COTTAGE GROVE PLANNING COMMISSION

STAFF REPORT CASE: CP/ZA/PUD/PP2024-015

REQUEST: A Comprehensive Plan Amendment, Preliminary Plat, Rezoning, and a Planned Unit Development (PUD) for a project to be known as Preserve at Prairie Dunes that would consist of 162 single-family homes on approximately 60 acres.

Planning Staff Report
Preserve at Prairie Dunes
Planning Case Nos. ZA2024-015, PP2024-015,
PUD2024-015 & CP2024-015
July 22, 2024

PRELIMINARY STREET &
UTILITY PLAN

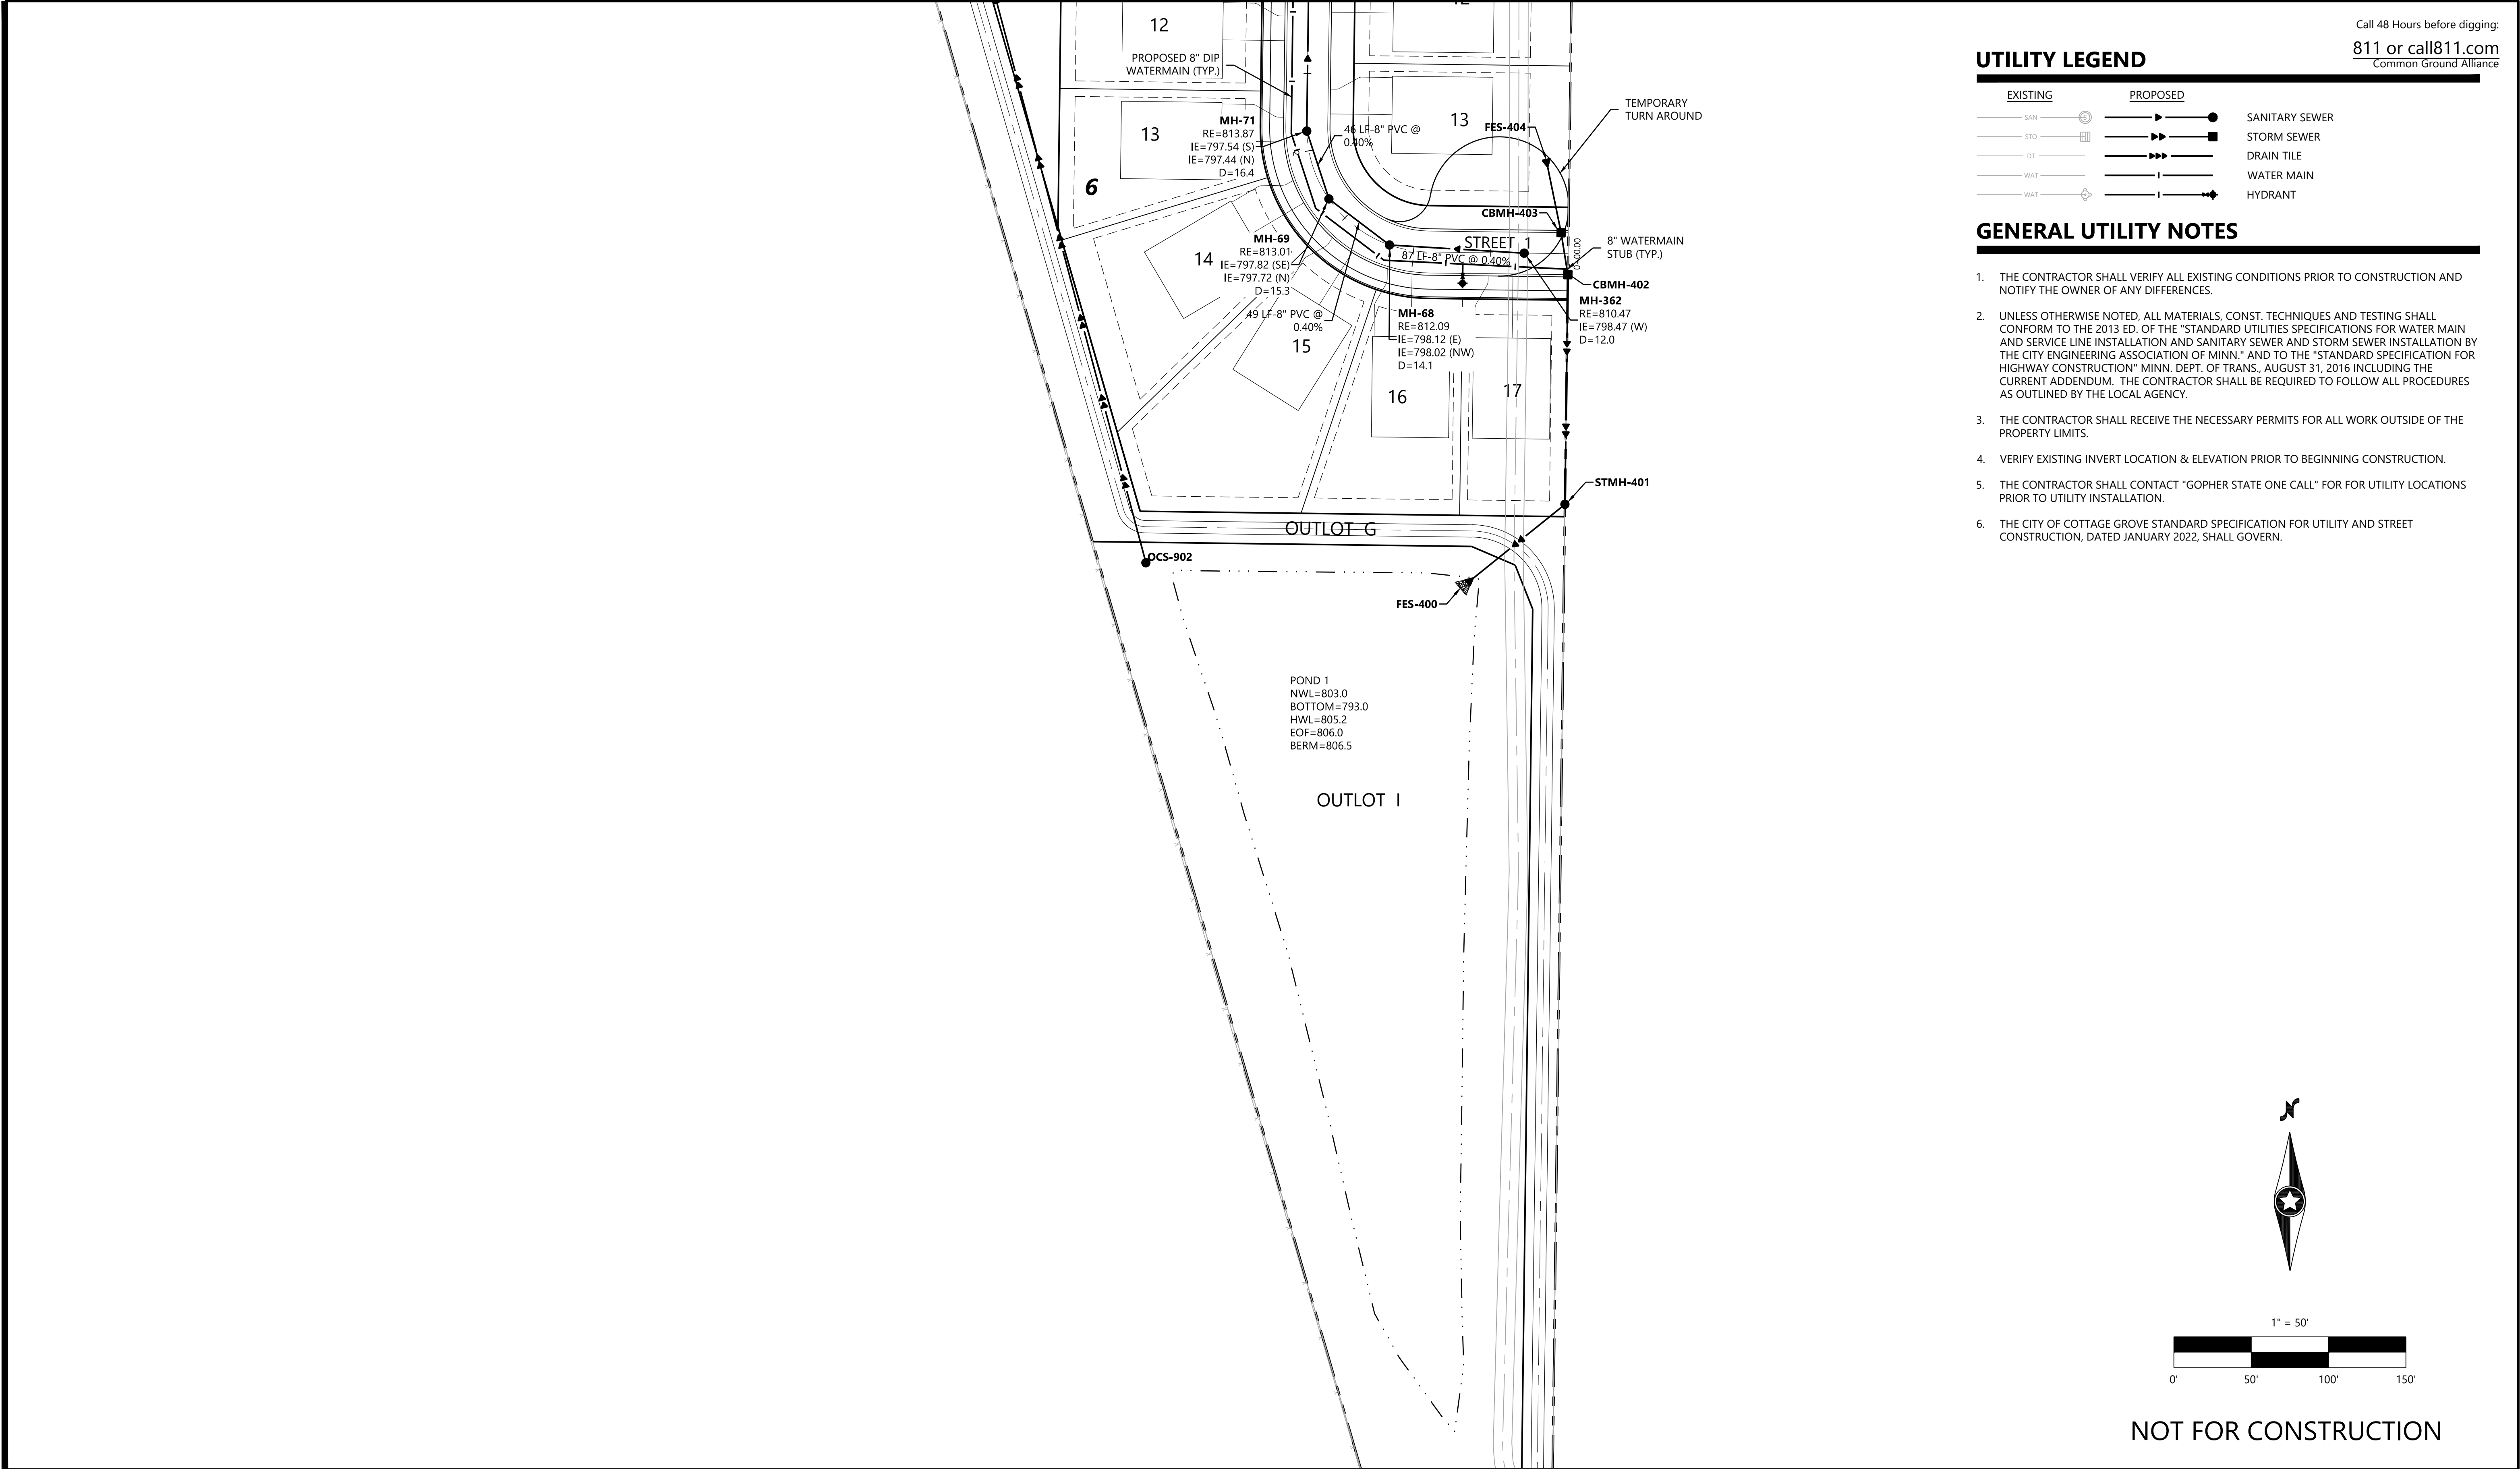
Preliminary Street & Utility Plan Comments (sheets 14 – 23):

OVERALL PRELIMINARY
LANDSCAPE PLAN

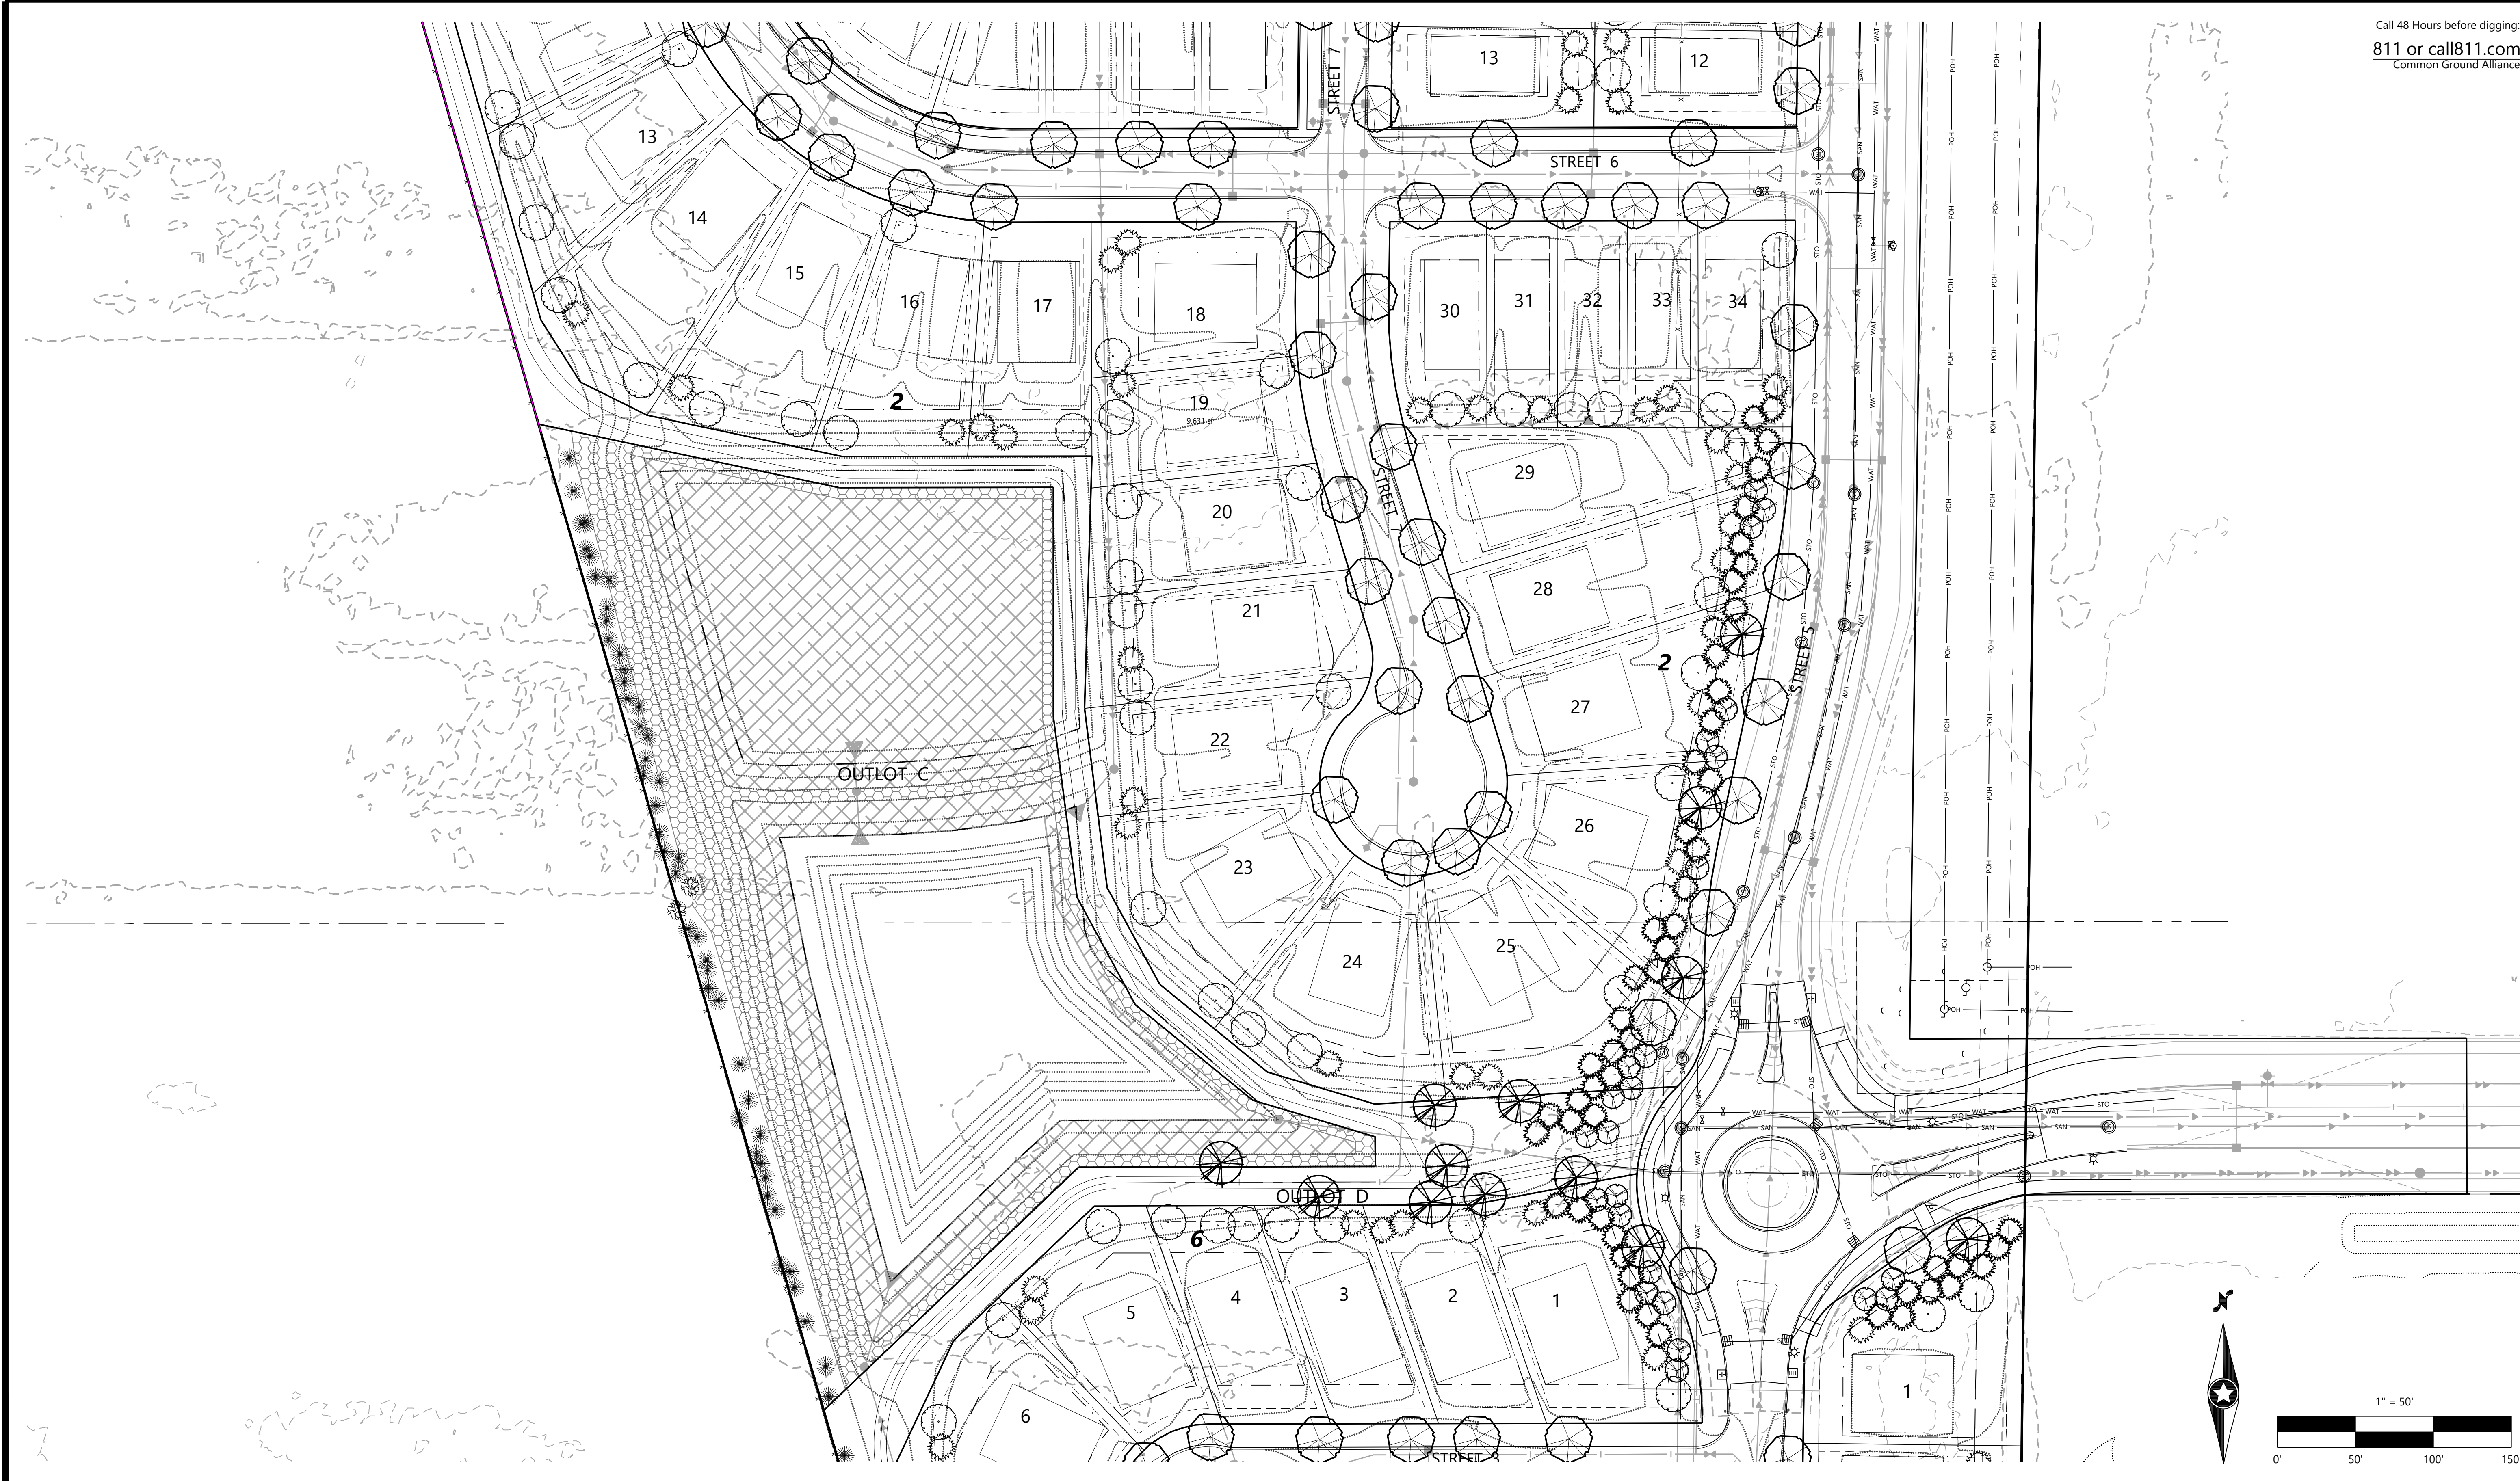
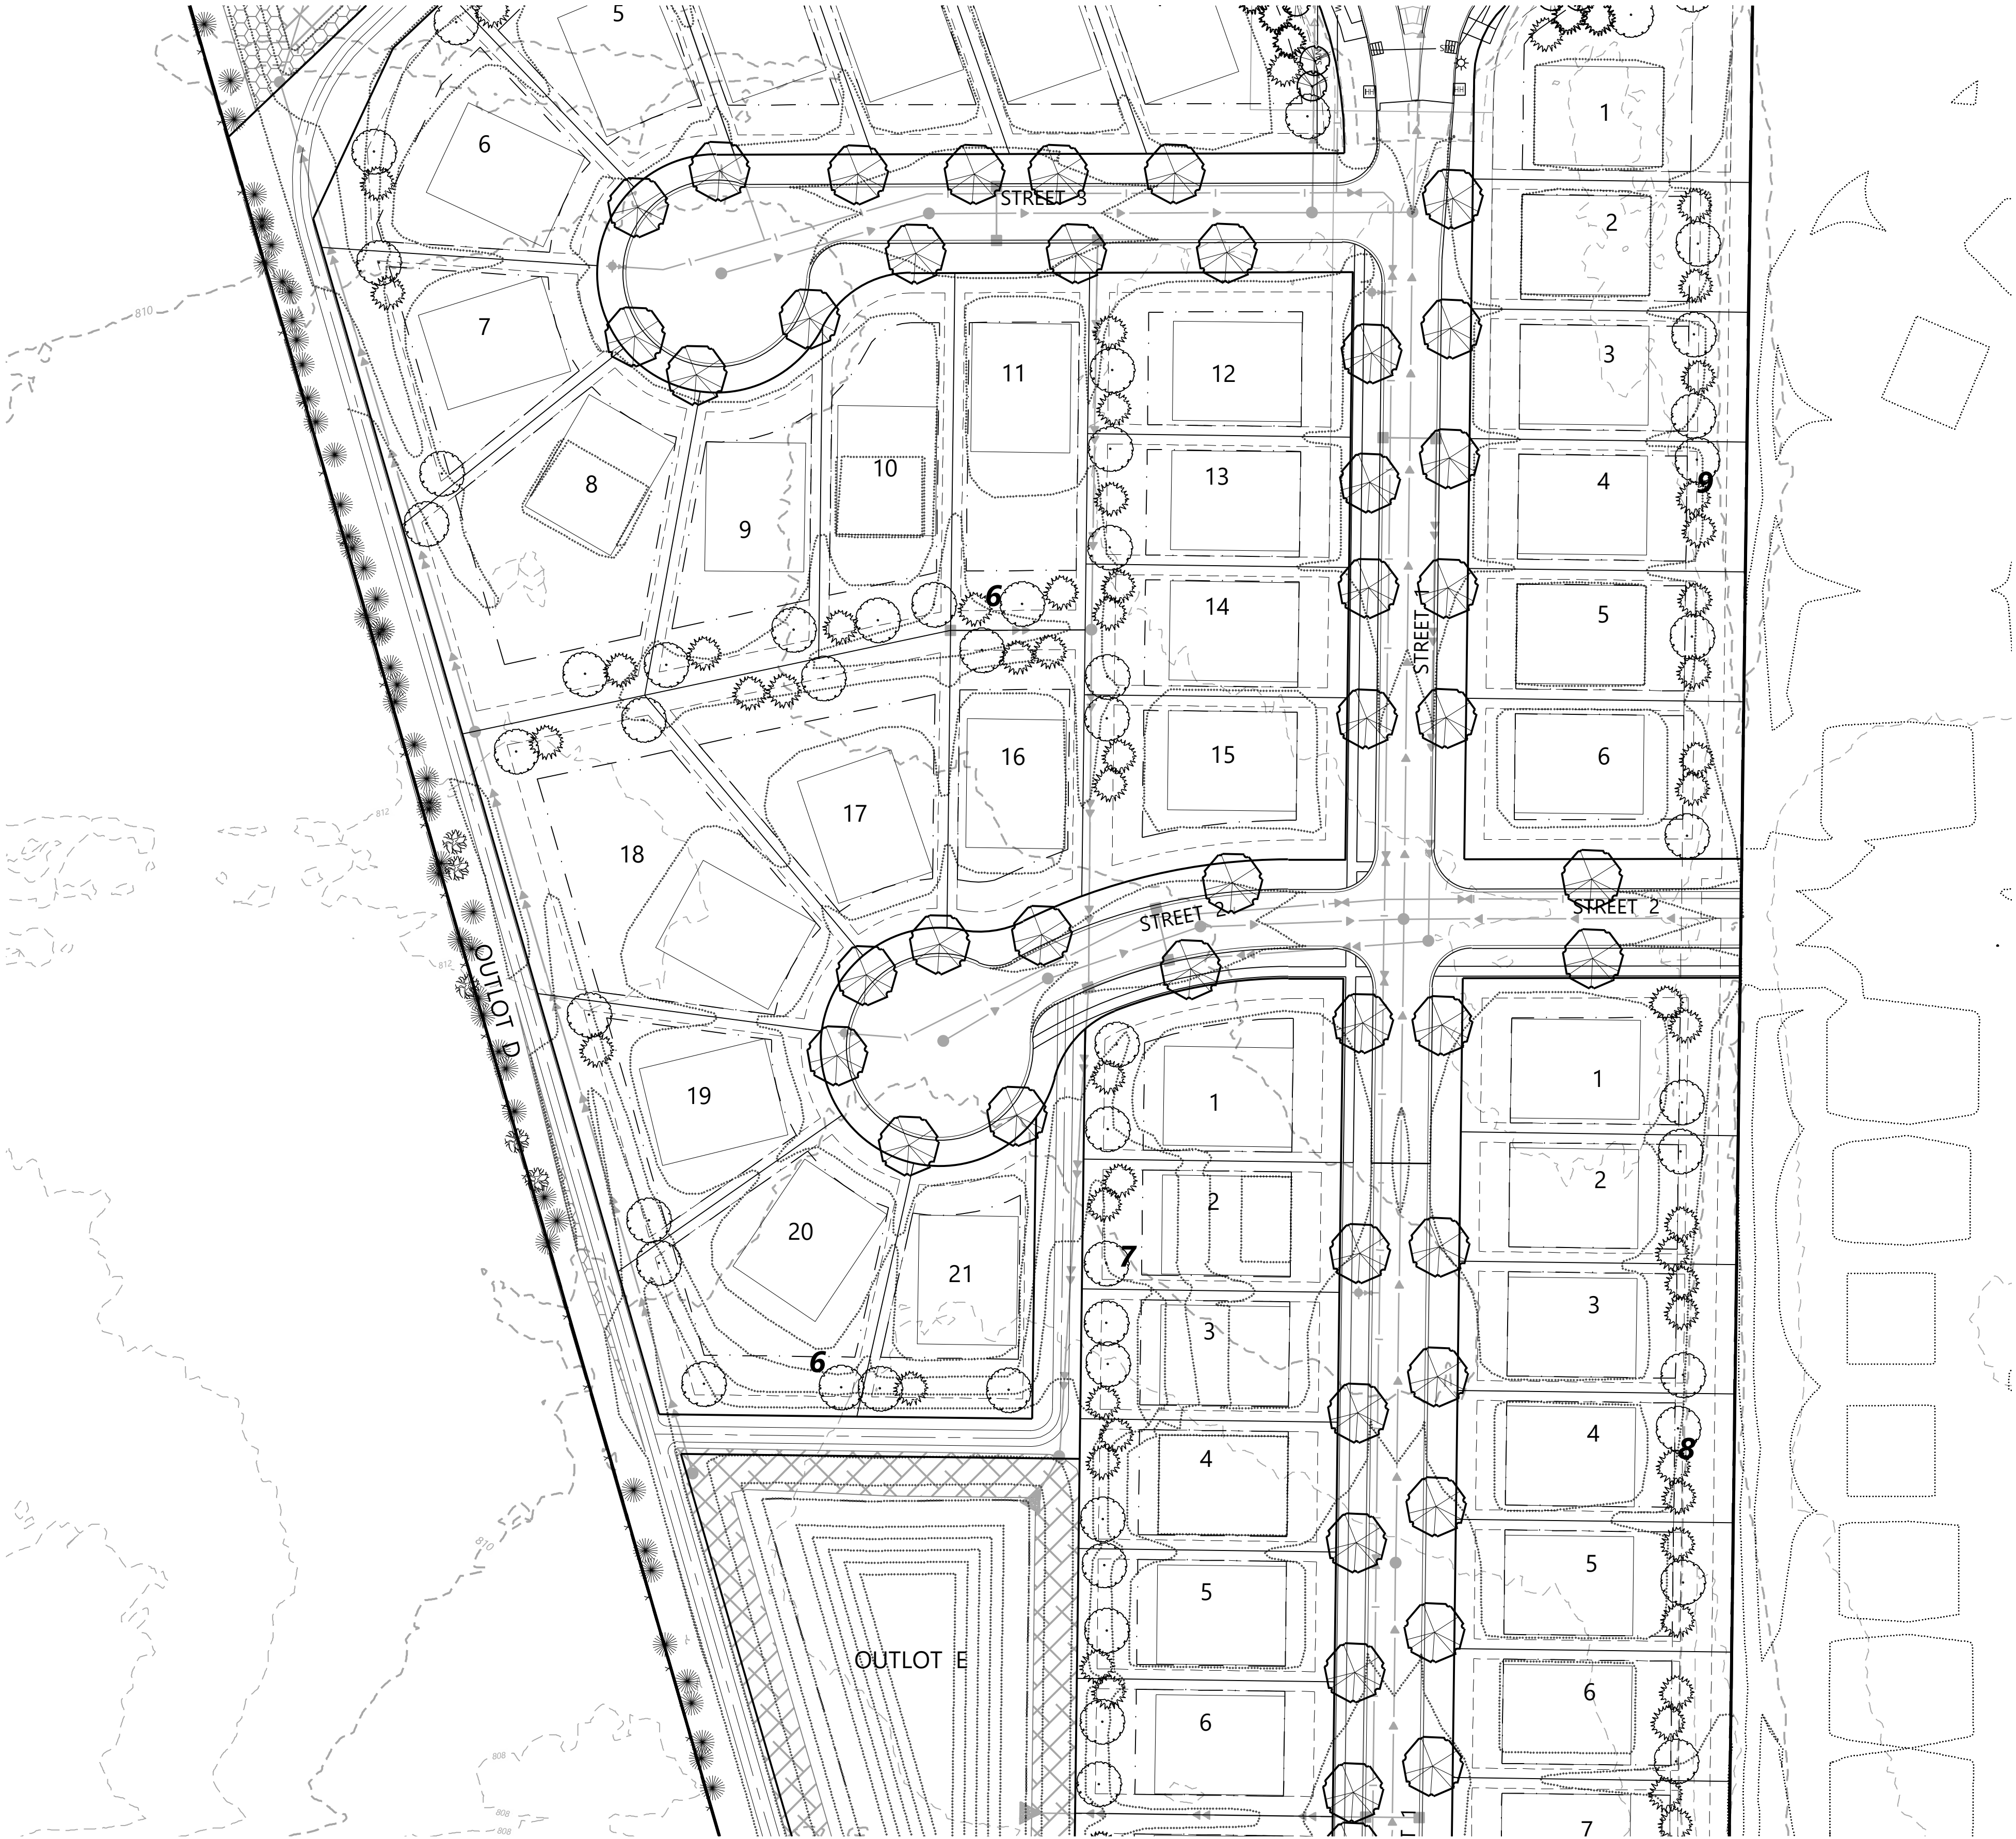
Preliminary Landscape Plan Comments (sheets 24 - 34):
